RFP NO. ASPA24.052 – Construction of Aua ACP Replacement Project

Addendum No. 2

- a. Alternative Above Grade Stream Crossing Details**
- b. Sign in sheet and notes from Mandatory Pre-Bid Meeting held on 9/27/2024, and Mandatory Site Visit held on 10/01/2024. Please note a separate addendum will be posted addressing some of the questions raised during these meetings.**
- c. Revised Bid Form (marked with Revised 2024-10-17; disregard previous versions)**

1 **BRIDGE UPSTREAM**
Scale: NTS

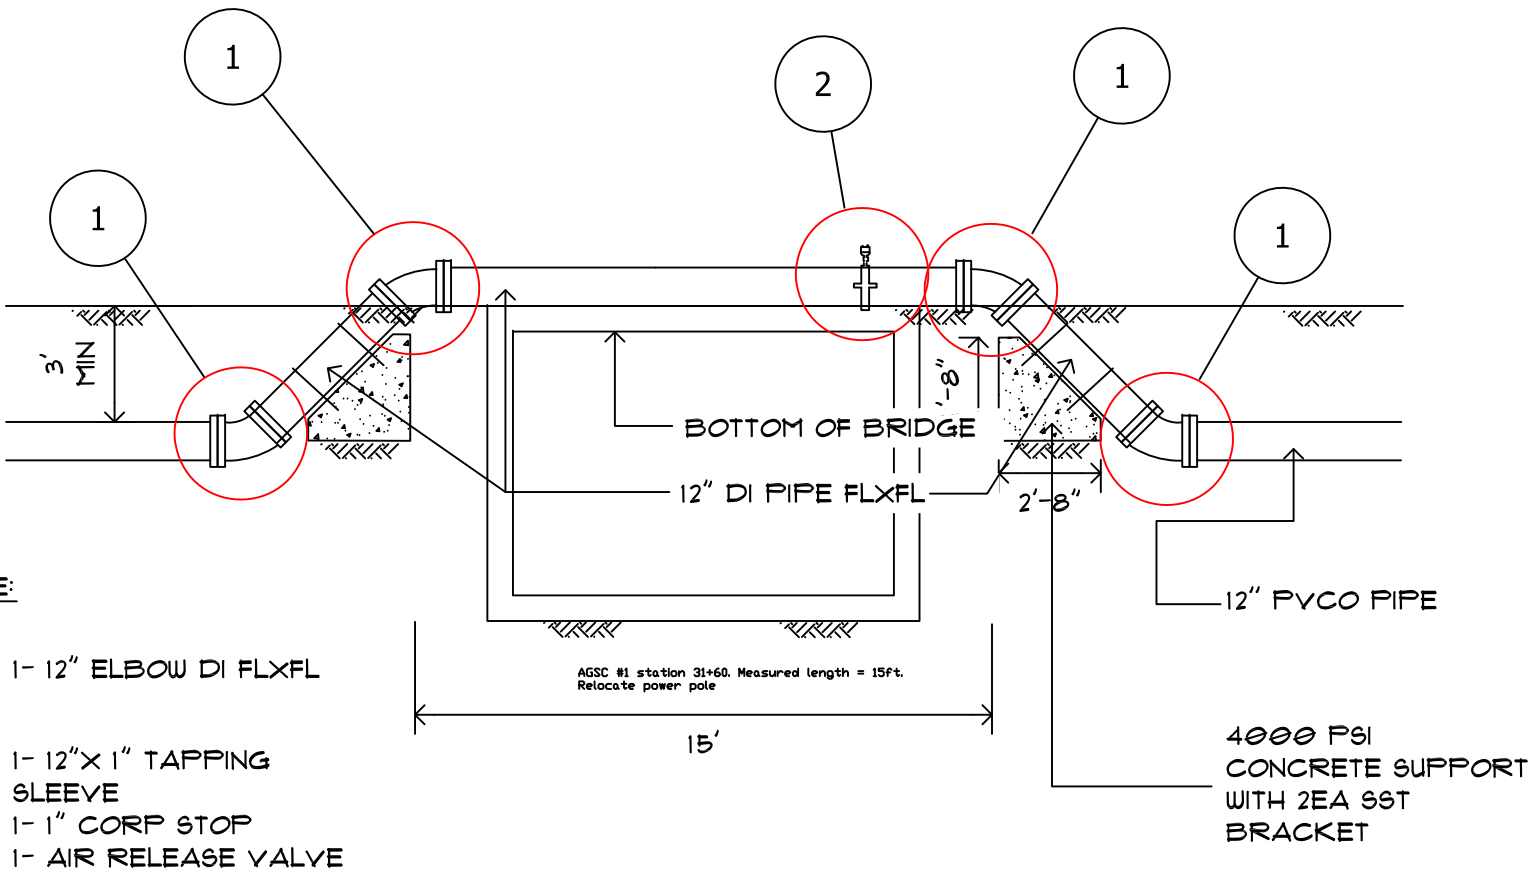
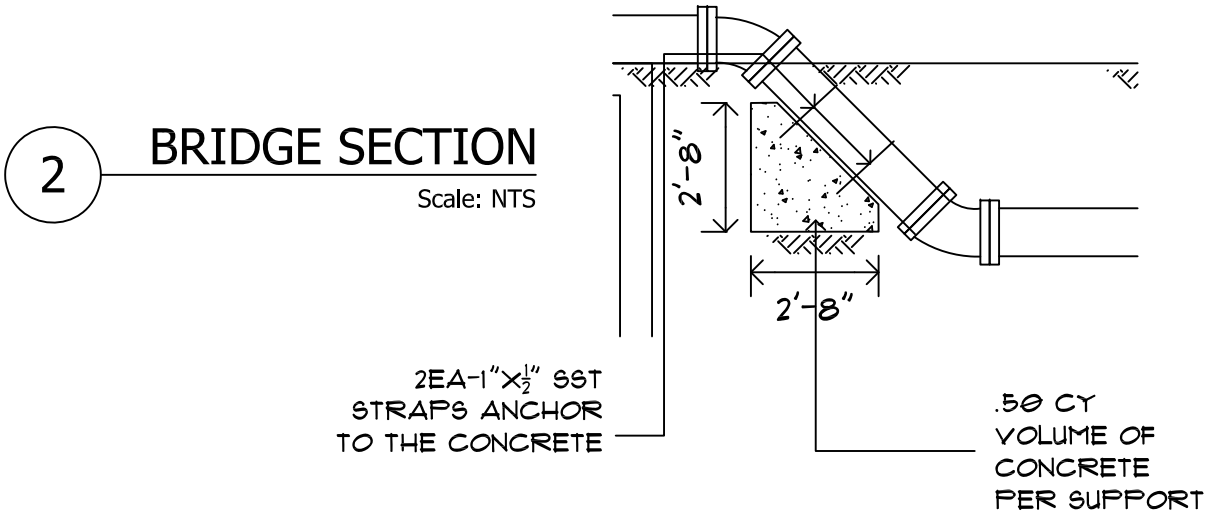
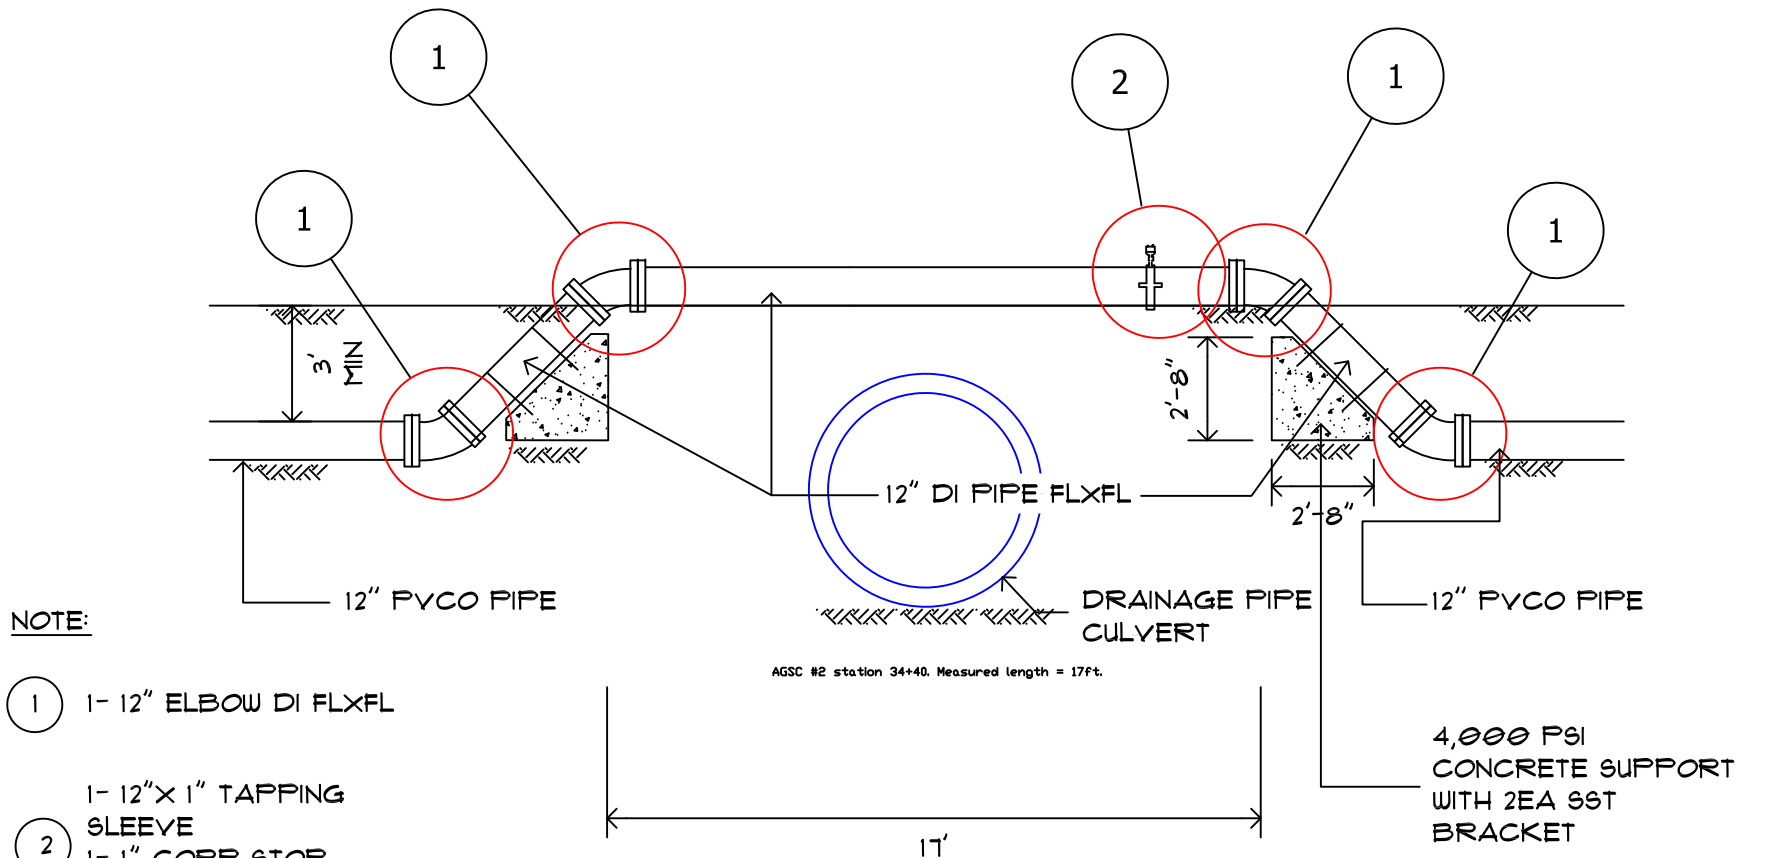
1. ANY STRUCTURE THAT IS AFFECTED DURING INSTALLATION SHALL BE RESTORED, AND THIS RESTORATION COSTS SHALL BE INCIDENTAL TO THE PIPE CROSSING INSTALLATION

- NOTE:
- 1 1- 12" ELBOW DI FLXFL
 - 2 1- 12"X 1" TAPPING SLEEVE
1- 1" CORP STOP
1- AIR RELEASE VALVE

1 BRIDGE SECTION

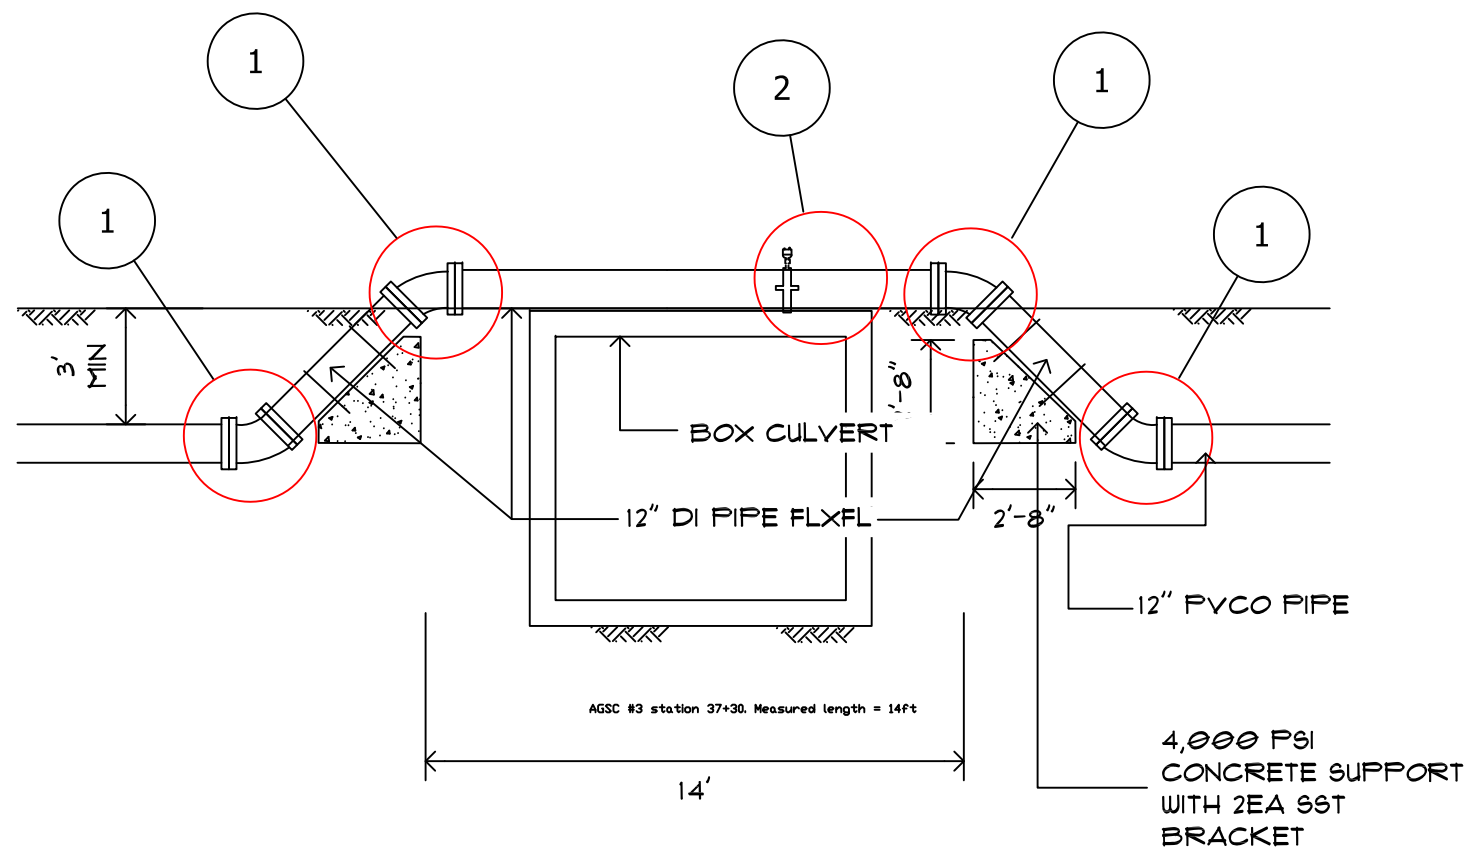
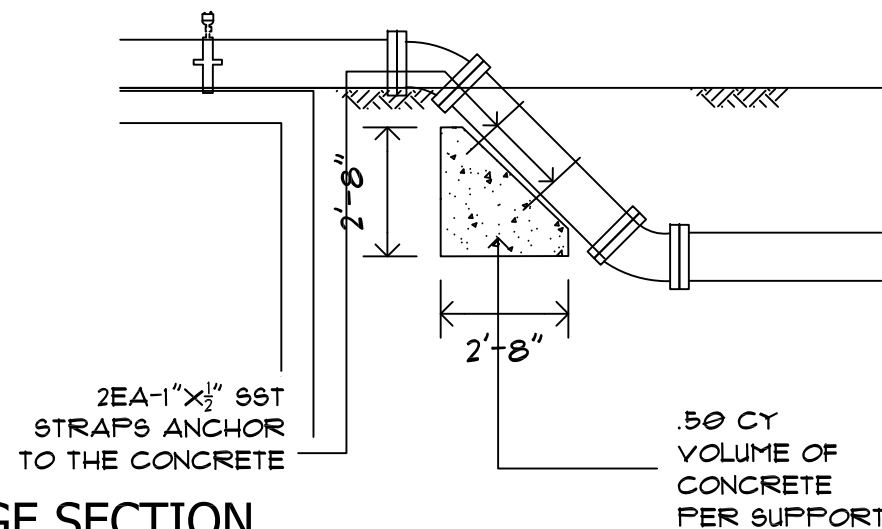
- ① 1- 12" ELBOW DI FLXFL
- 1- 12"x 1" TAPPING SLEEVE
- ② 1- 1" CORP STOP
- 1- AIR RELEASE VALVE

- 1. ANY STRUCTURE THAT IS AFFECTED DURING INSTALLATION SHALL BE RESTORED, AND THIS RESTORATION COSTS SHALL BE INCIDENTAL TO THE PIPE CROSSING INSTALLATION

An alternative to a typical Underground Utility Crossings is this above grade stream crossing as specified on the detail drawing Titled: Stream Crossing (STA 37+30). The above price shall include all supervision, certified personnel in water pipe installation, labor, equipment, corrosion protection wrapping, required tests and permits, bedding under pipe, backfill, restoration, dewatering as needed, and all non-plumbing materials necessary for this work as specified, shown in the drawings and/or as directed by APE.

PROJECT NAME: AUA ACP REPLACEMENT PROJECT	SCALE: NTS	PROJECT NO: ASPA24.052	
DRAWING TITLE: STREAM CROSSING (STA 56+75)			
PROJECT LOCATION: AUA VILLAGE, AMERICAN SAMOA	DATE: OCT2024	SHEET NO. SC-5	SIGNATURE: DATE:

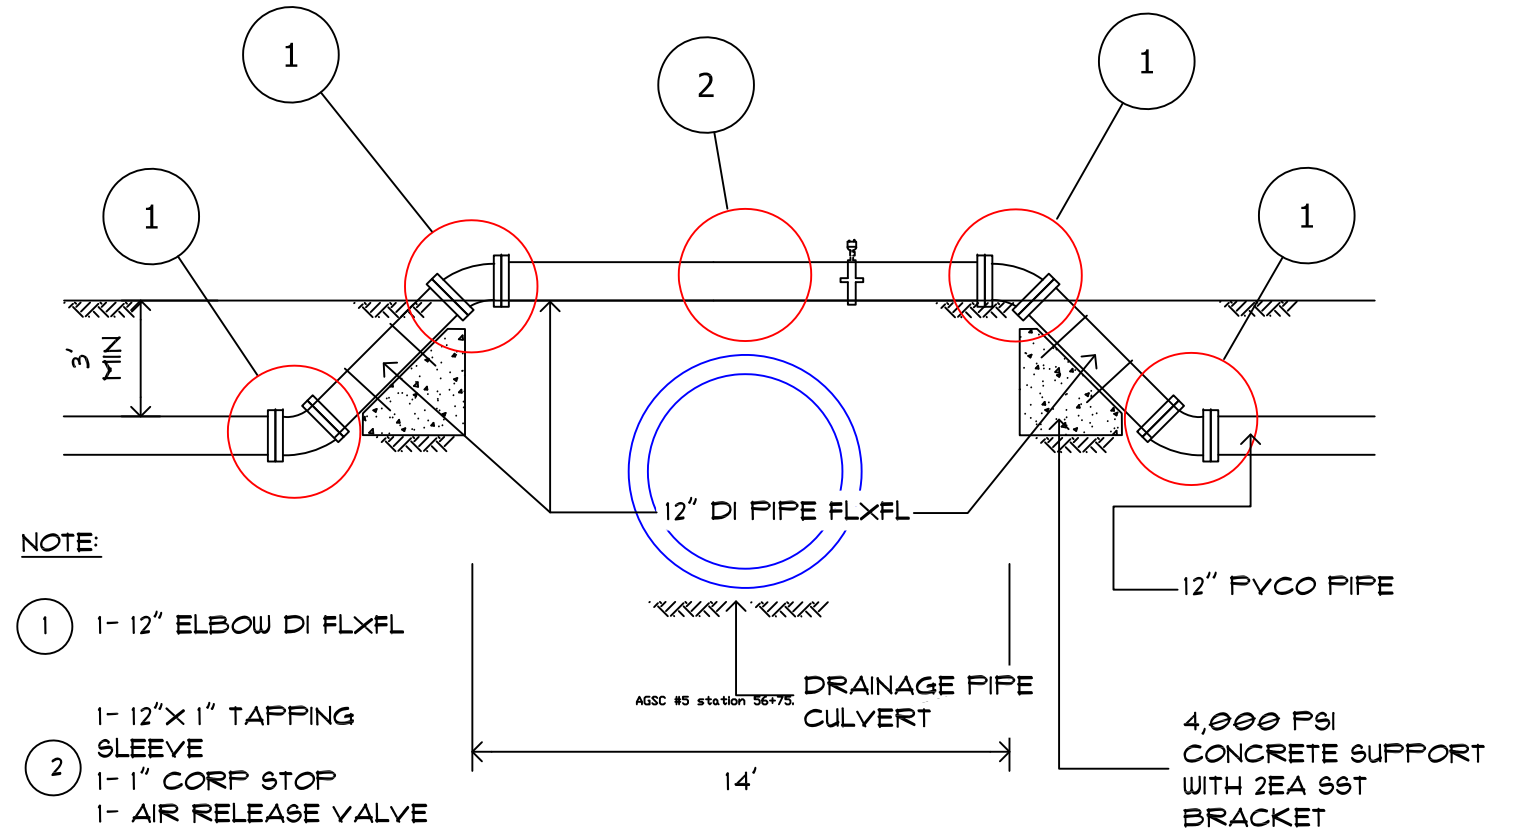
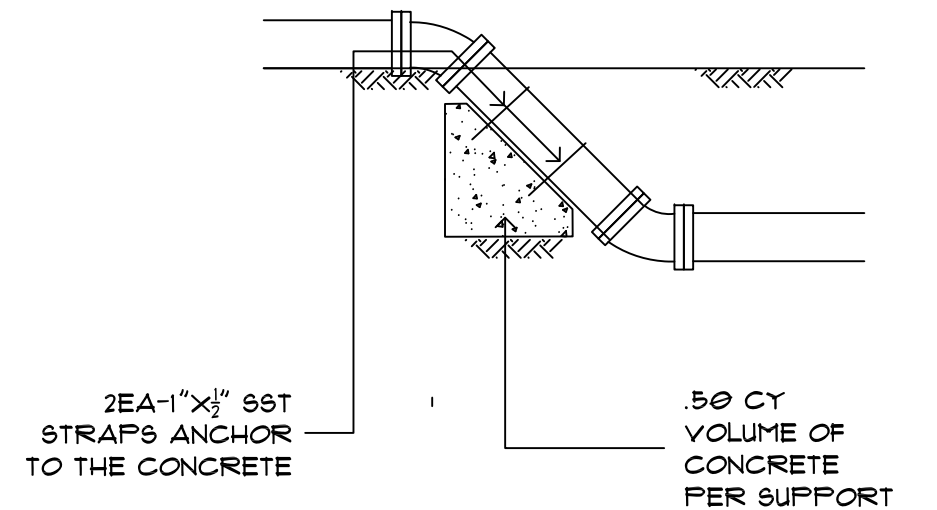
- 1 1- 12" ELBOW DI FLXFL
1- 12"X 1" TAPPING SLEEVE
1- 1" CORP STOP
1- AIR RELEASE VALVE

1. ANY STRUCTURE THAT IS AFFECTED DURING INSTALLATION SHALL BE RESTORED, AND THIS RESTORATION COSTS SHALL BE INCIDENTAL TO THE PIPE CROSSING INSTALLATION

An alternative to a typical Underground Utility Crossings is this above grade stream crossing as specified on the detail drawing Titled: Stream Crossing (STA 56+75). The above price shall include all supervision, certified personnel in water pipe installation, labor, equipment, corrosion protection wrapping, required tests and permits, bedding under pipe, backfill, restoration, dewatering as needed, and all non-plumbing materials necessary for this work as specified, shown in the drawings and/or as directed by APE.

PROJECT NAME: AUA ACP REPLACEMENT PROJECT	SCALE: NTS	PROJECT NO: ASPA24.052	
DRAWING TITLE: STREAM CROSSING (STA 13+20 ROUTE B)			
PROJECT LOCATION: AUA VILLAGE, AMERICAN SAMOA	DATE: OCT2024	SHEET NO. SC-6	SIGNATURE: DATE:

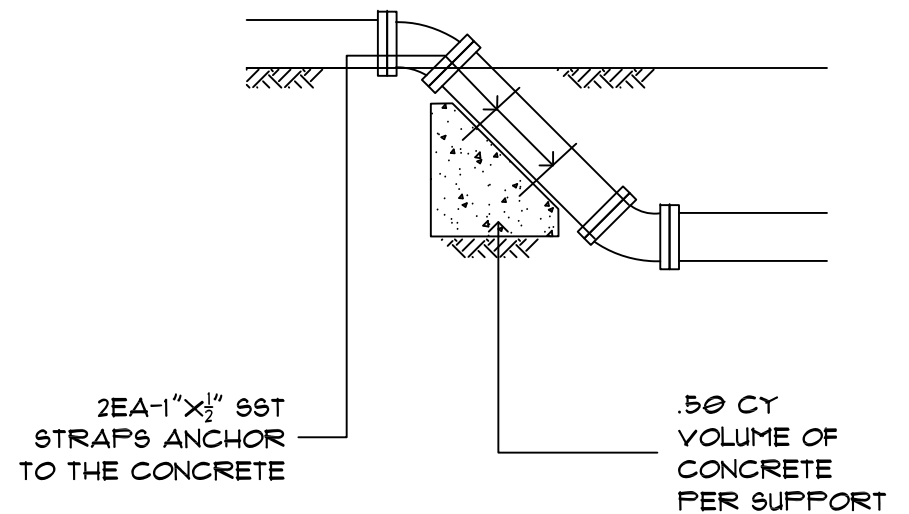
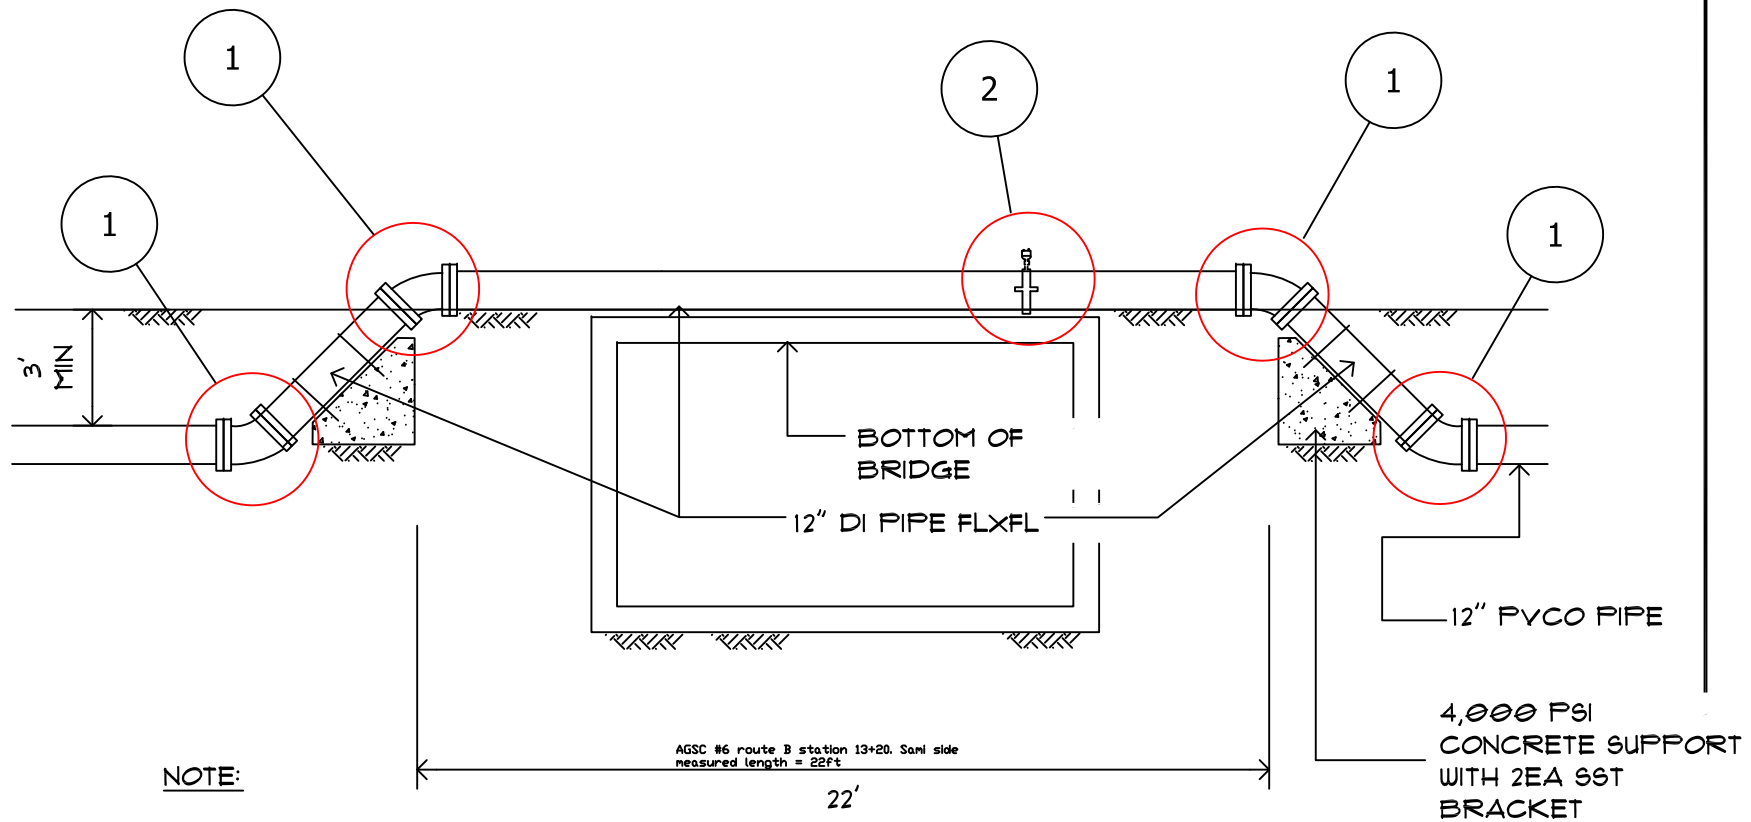
An alternative to a typical Underground Utility Crossings is this above grade stream crossing as specified on the detail drawing Titled: Stream Crossing (STA 13+20 Route B). The above price shall include all supervision, certified personnel in water pipe installation, labor, equipment, corrosion protection wrapping, required tests and permits, bedding under pipe, backfill, restoration, dewatering as needed, and all non-plumbing materials necessary for this work as specified, shown in the drawings and/or as directed by APE.

STREAM CROSSING (STA 15+00 ROUTE B)

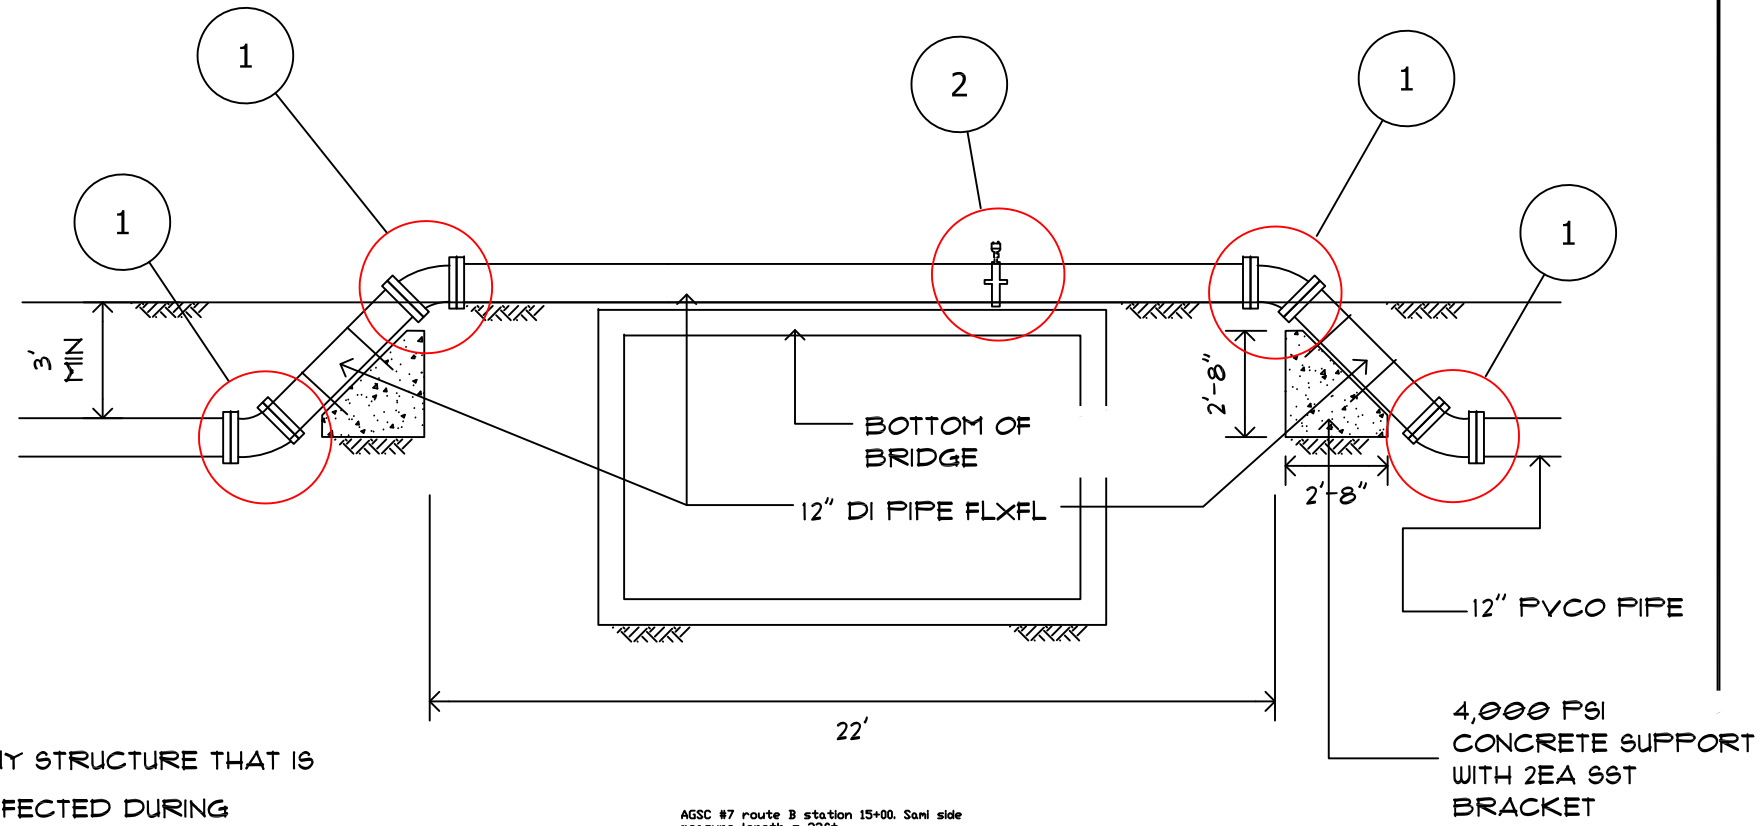
1. ANY STRUCTURE THAT IS AFFECTED DURING INSTALLATION SHALL BE RESTORED, AND THIS RESTORATION COSTS SHALL BE INCIDENTAL TO THE PIPE CROSSING INSTALLATION

- 1 1- 12" ELBOW DI FLXFL
- 1- 12"X 1" TAPPING SLEEVE
1- 1" CORP STOP
1- AIR RELEASE VALVE

2EA-1"X $\frac{1}{2}$ " SST STRAPS ANCHOR TO THE CONCRETE

.50 CY VOLUME OF CONCRETE PER SUPPORT

An alternative to a typical Underground Utility Crossings is this above grade stream crossing as specified on the detail drawing Titled: Stream Crossing (STA 15+00 Route B). The above price shall include all supervision, certified personnel in water pipe installation, labor, equipment, corrosion protection wrapping, required tests and permits, bedding under pipe, backfill, restoration, dewatering as needed, and all non-plumbing materials necessary for this work as specified, shown in the drawings and/or as directed by APE.
